CIIPC Cover Letter

This CIIPC was initiated on behalf of Sirius XM Satellite Radio to support the changes being executed on the Bluetooth Vehicle Dock (RS2SXBTD1). A summary of the changes are mentioned below, but could also be referenced in detail from the supporting test report accompanying this application.

Photograph 1: Top Side Changes

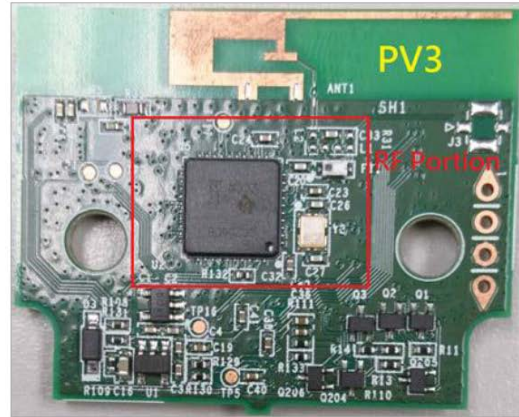
Component changes to improve overall performance of the device.

1. Changed the value of R108 to 1.2Kohm.
2. Changed the value of R109 to 270Kohm.
3. Removed U4, C18, C19, C14, R10, R12, R15 and R30.
4. Removed R25, R27, R28 and R29.
5. Added Q206, Q209, D3, U9, U10, U11 and U15.
6. Added R111, R128, R129, R130, R131, R132, R133, R114 and R113.
7. Added C36, C43, C38, C39, C40 and C41.
8. Added J6.
